# Safety Evaluation Report

## Renewal of the Facility Operating License for the Rhode Island Nuclear Science Center Reactor

License No. R-95  
Docket No. 50-193

United States Nuclear Regulatory Commission

**Figure 4-2 RINSC Reactor Core Layout**

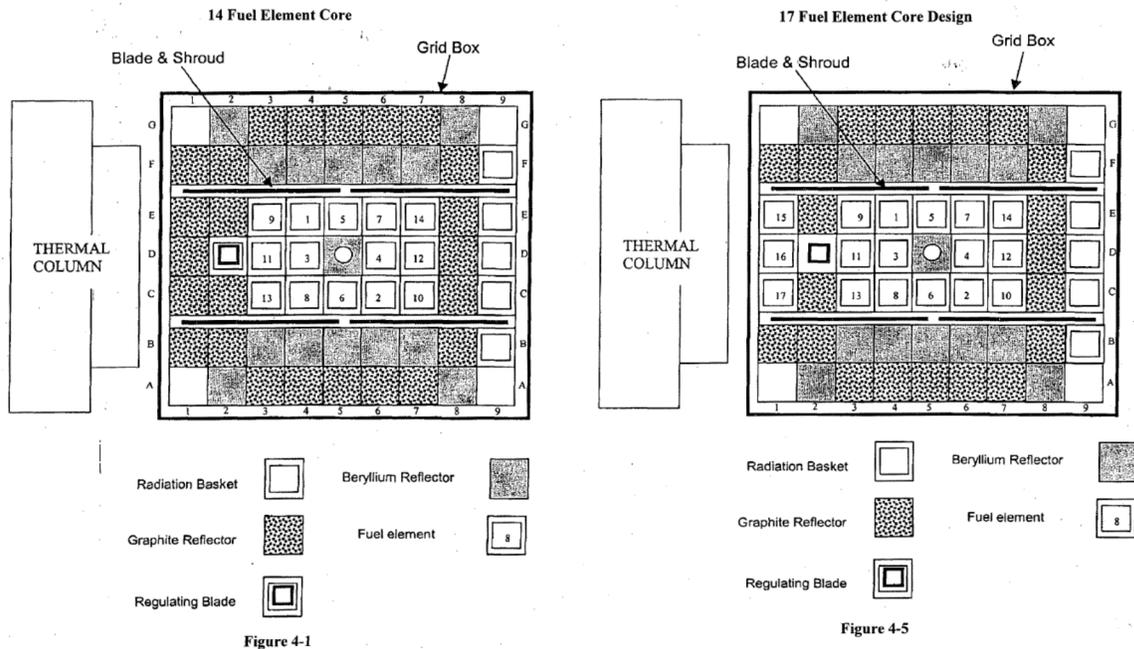
TS 5.4.1 requires the reactor core be assembled using a grid box of the stated dimensions. The NRC staff finds that this specification is consistent with the construction of the facility as shown in SER Figure 4-2 and as observed during site visits. The NRC staff also finds that this specification helps ensure that core configuration is controlled in a manner as to be consistent with the analysis provided. On the basis of this information, the NRC staff concludes that TS 5.4.1 is acceptable.

**Figure 4-4 Reactor Pool Dam**

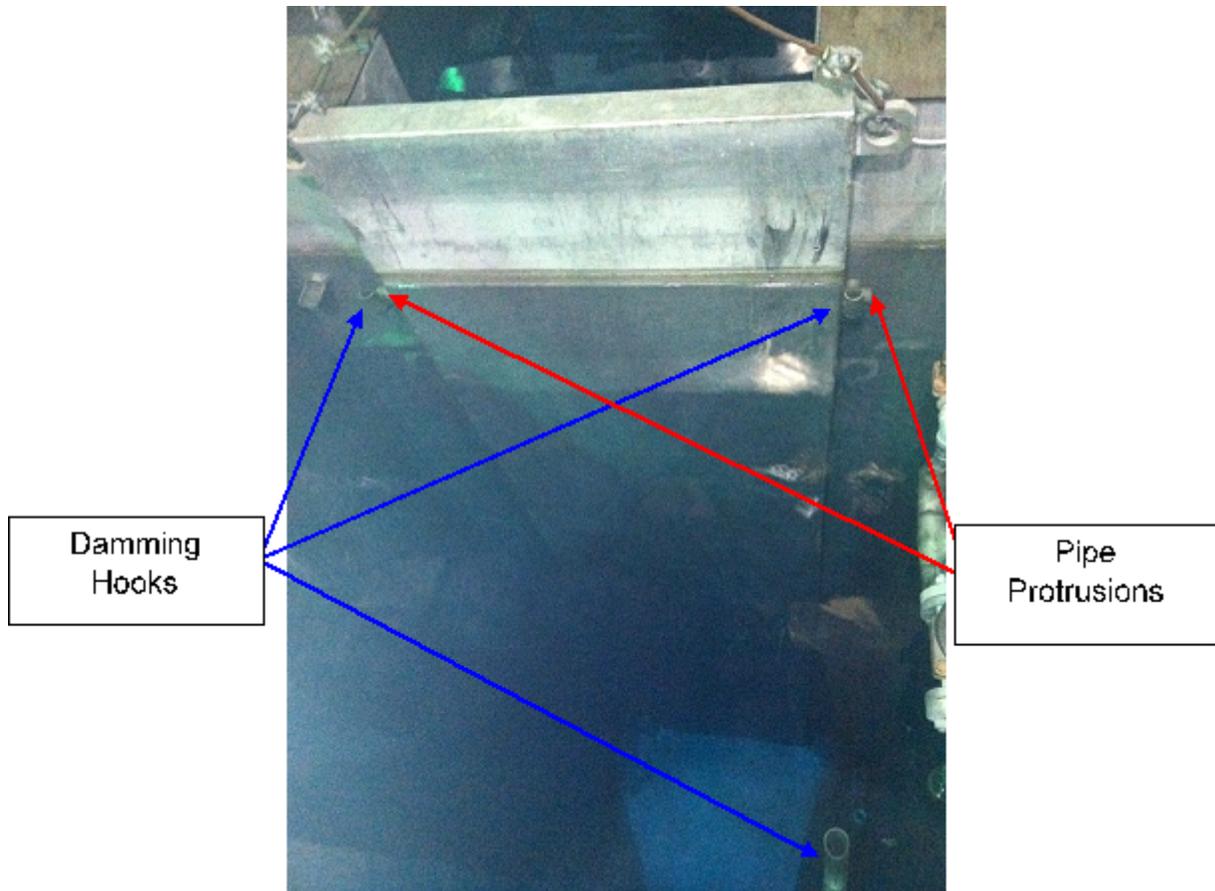
TS 4.1.2.2 requires a surveillance to verify that the pool dam is in the storage location before operating the reactor. This specification helps to ensure that the pool volume assumed in the T&H and LOCA analysis is available to provide a heat sink for the fuel as well as maintaining the expected level of shielding. The NRC staff finds that this specification is consistent with the guidance stipulated in NUREG-1537 and ANSI/ANS-15.1-2007, and the surveillance interval is reasonable. Based on the information above, the NRC staff concludes that TS 4.1.2.2 is acceptable.

**Figure 4-5 PLTEMP/ANL Forced Flow Model**

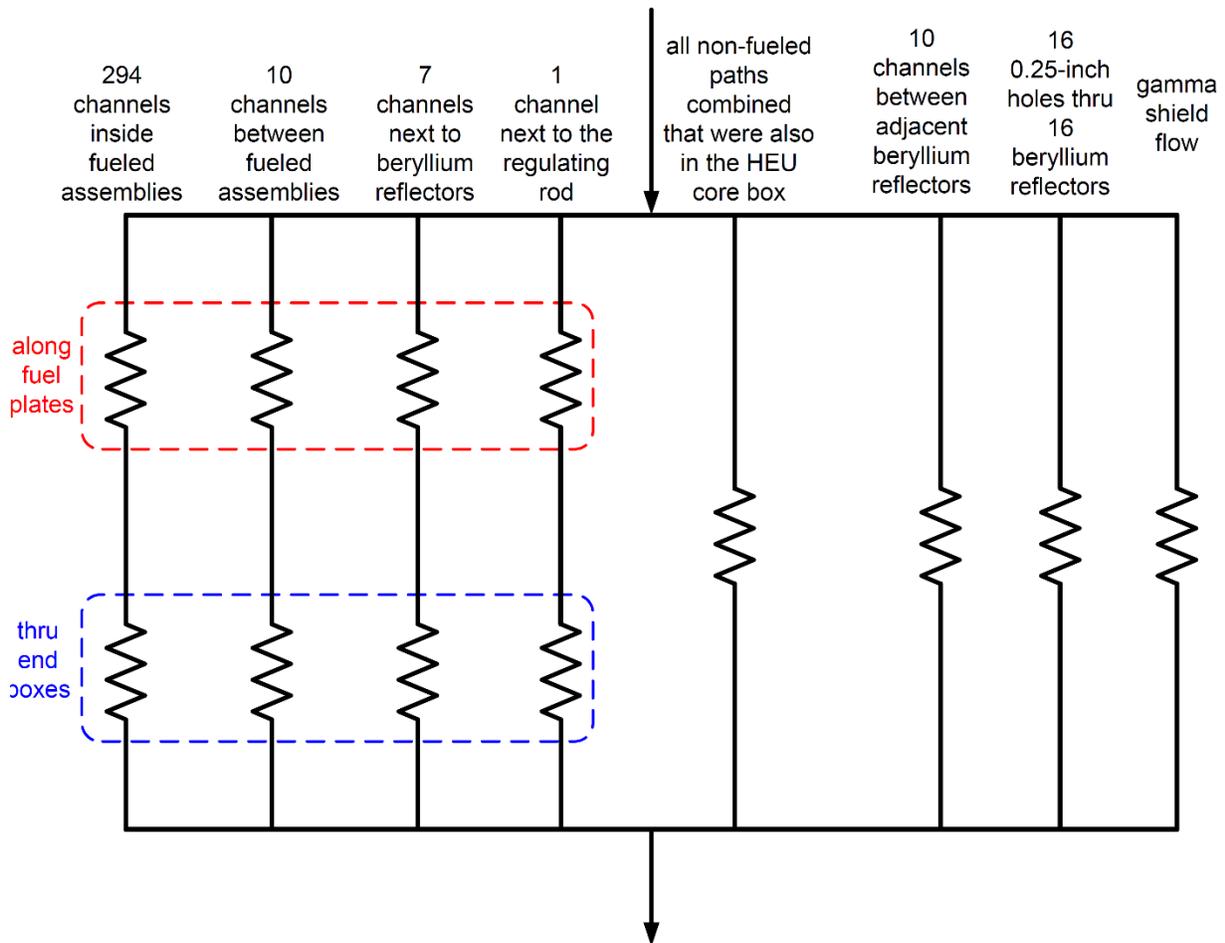
The PLTEMP/ANL model for forced flow is shown in Figure 4-5. In this down-flow model, a common source pressure exists at the top of the assemblies and a common sink pressure exists in the outlet plenum. Differences in the velocity of the coolant between the source and sink regions are assumed to be small and are ignored. The thermal column gamma shield

hydraulics have the same inlet and outlet pressures as is assumed for the fuel assemblies. The inlet to the gamma shield is connected to the core inlet pipe. The outlet to the gamma shield is connected to the core outlet pipe. However, the flow through the gamma shield is not part of the flow rate cited in the results.

**Figure 12-1 Rhode Island Atomic Energy Commission Organization Chart (Reproduced from Figure 6-1 of TS [Ref. 60])**

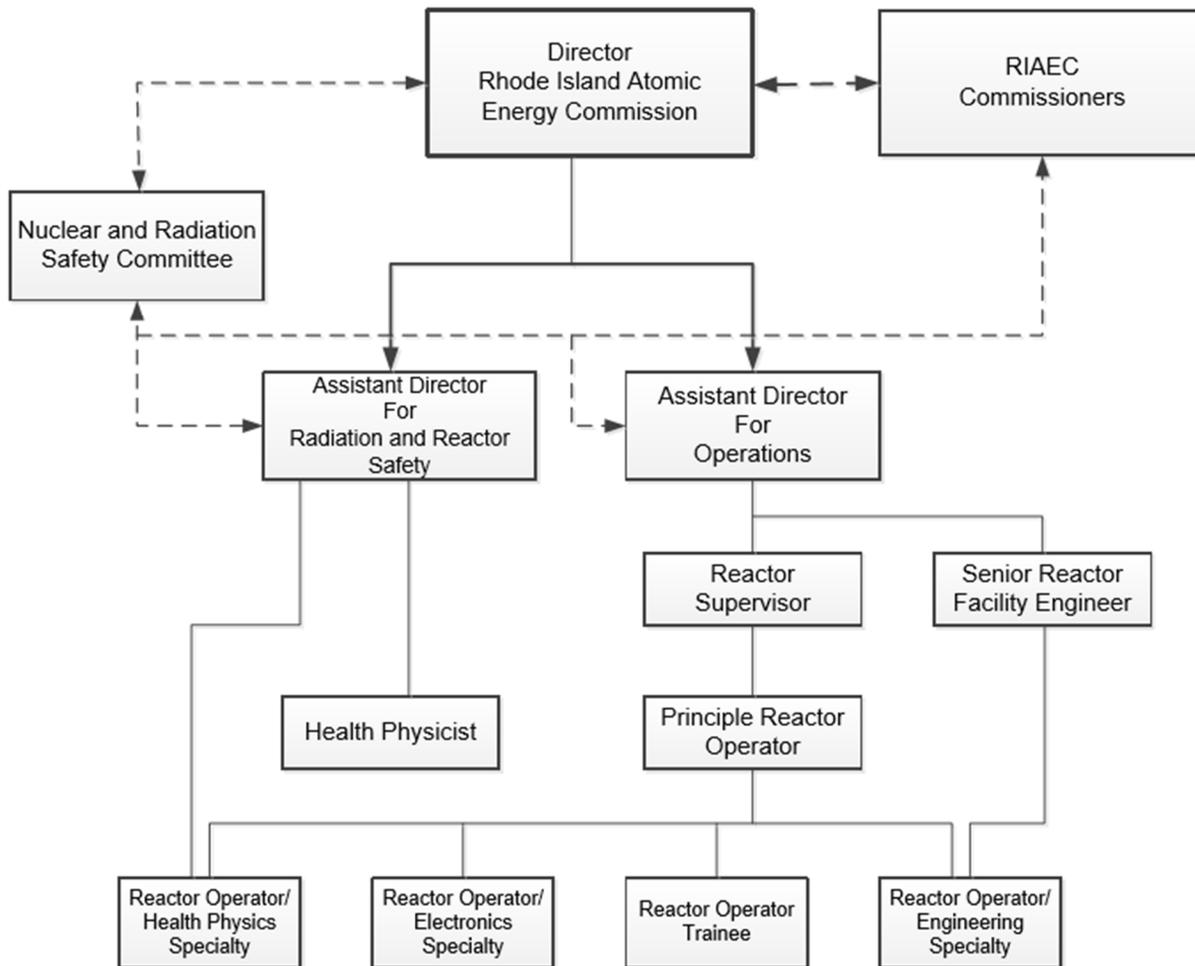
TS 6.1.1 establishes the organizational structure of the RINSC staff. This specification helps ensure that the RINSC organization structure is properly delineated and understood. The staff notes that on TS Figure 6.1 (SER Figure 12-1) solid and dotted lines are not defined. The licensee confirmed (Ref 58) that the lines are defined as shown in ANSI/ANS-15.1-2007, where solid lines are reporting lines and dotted lines are communication lines. The RINSC organizational structure described in this specification and shown in RINSC TS Figure 6.1, is consistent with the guidance in ANSI/ANS-15.1-2007, Section 6.1.1, as accepted in NUREG-1537. Based on the information above, the NRC staff concludes that TS 6.1.1 is acceptable.

**Figure 13-1 Experimental Drain System**

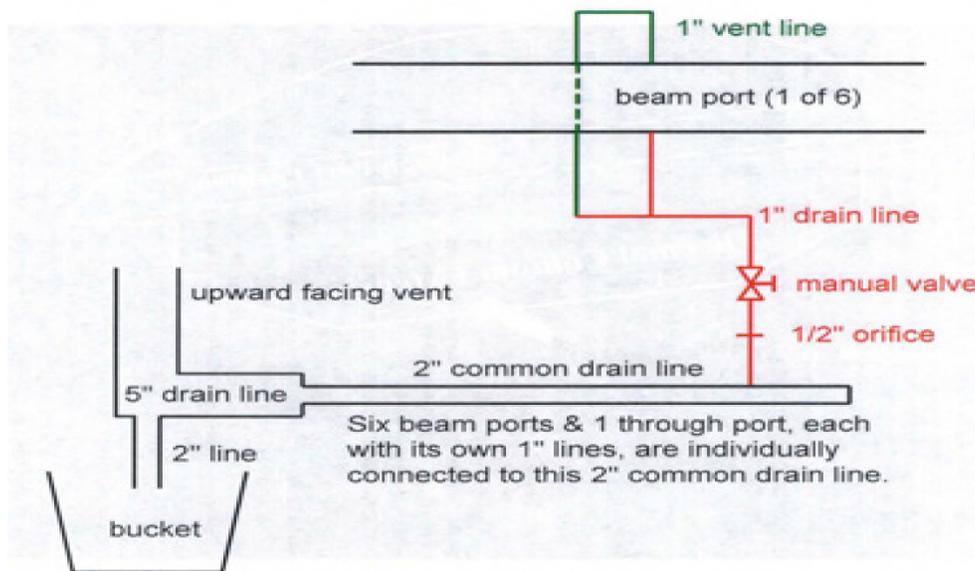
In response to RAI 13.10 (Ref. 3), the licensee stated that the design basis accident for RINSC is the in-pool shearing of a beam port, and each beam port has a 1 in diameter drain line, and a 1 in diameter vent line. These lines merge into a single 1-in line at an elevation below the bottom of the beam port, extend out to the confinement edge of the reactor pool wall, and go through a manual drain valve. On the outlet side of the drain valve there is a one-half in diameter orifice plate welded onto the drain line. The 1-in drain line connects to a 2 in diameter drain line that is common to all of the beam ports, as well as the through port. This common line also connects to the 1-in drain line for the through port, and the 5 in off gas vent for the thermal column. The common drain line is well below the elevations of the beam ports, through port, and thermal column, and it connects to a 5-in drain line that extends into the basement underneath the reactor. The 5-in line is capped with a pipe tee that is positioned vertically. The upward facing vent ultimately ties into the Off-Gas System. The downward facing drain diameter is reduced to a 2-in line that empties into a 5-gal bucket that is open to air. This is illustrated below in Figure 13-1 below provided by the licensee in response to RAI 10.2 (Refs. 3, 6).

The licensee stated in the response to RAI 13.10 (Ref. 3), that if an 8-in diameter beam port is sheared, it will flood. The water will have two possible pathways: (1) through the beam port drain line which is a ½ in diameter hole; or (2) through the opening in the beam port flange fitting which according to TS 3.9.3.1 is allowed to be as large as 1.25 in in diameter. The most constrictive point of the beam port drain line is the one-half inch diameter orifice on the drain line. Since this opens into progressively larger pipe diameters the limiting diameter for the drain line (.5 in) determines the maximum flow rate through the drain line.

Figure 13-2 Flow rates for the LOFA

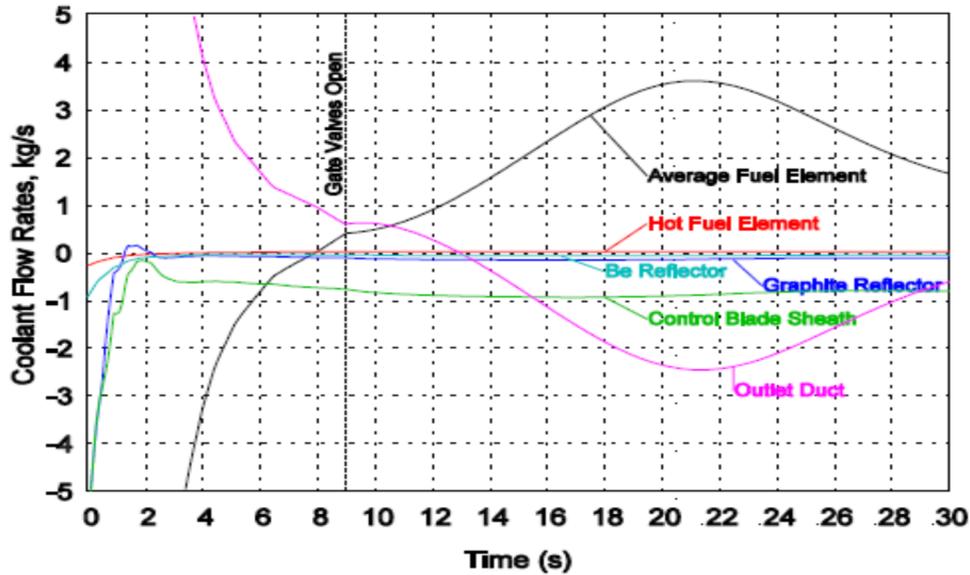
The NRC staff noted that the operating parameters cited in SAR Section 13.2.4.1 LOFA analysis did not match the limiting conditions in the TSs. In the response to RAIs 13.18 and 13.19 (Ref. 3), the licensee described the results of new LOFA analyses using RELAP5. In these analyses, the licensee used the trip setpoints values that are consistent with the TS LSSS for FC (TS 2.2.2). In these analyses, the licensee listed the initial conditions (limiting trip values), pump flow coast down, limiting conditions on the reactivity insertion and its timing, and the timing when the NC gate valve opens. For the case when the gate valves open (9 second after trip), the licensee's calculations show a maximum fuel clad temperature of 115.62 °C (240.12 °F), with a peak fuel temperature of 115.73 °C (240.31 °F) and a coolant saturation temperature of 115.90 °C (240.62 °F). These results indicate the coolant peak temperature to be close to the onset of sub-cooled boiling. The licensee added that at a higher initial power level, if sub-cooled boiling occurs, coolant heat transfer would increase and would limit the fuel and clad temperature rise.

For the case when the two gate valves fail to open, the licensee stated that the peak clad temperature is slightly lower (115.61 vs. 115.62 °C), and occurs at the same timeframe (at 9.41 seconds). The reason for the lower peak temperature when the gate valves do not open can be attributed to the changes in the amount of flow that is drawn out of the outlet duct. As shown in Figure 13-2, the flow rate near 9 seconds after the event initiation indicates that the outlet duct upward flow rate immediately after the gate valves open is slightly higher than what would be obtained by extrapolating the flow rate from before the gate valves open. The slightly increased coolant being drawn out of the outlet plenum causes slightly less up-flow through the fuel channels and slightly higher temperatures in the fuel channels than if the gate does open. However, it is desirable to have the gates open for long-term NC cooling.

The NRC staff has reviewed the new LOFA analysis and finds that the assumptions used in the analysis are acceptable. The licensee’s steady-state FC T-H analysis (Ref. 3) establishes initial conditions that are slightly different than those used in the LOFA analysis. Table 13-9 summarizes the initial conditions used in the LOFA and those used in the steady-state T-H analysis.
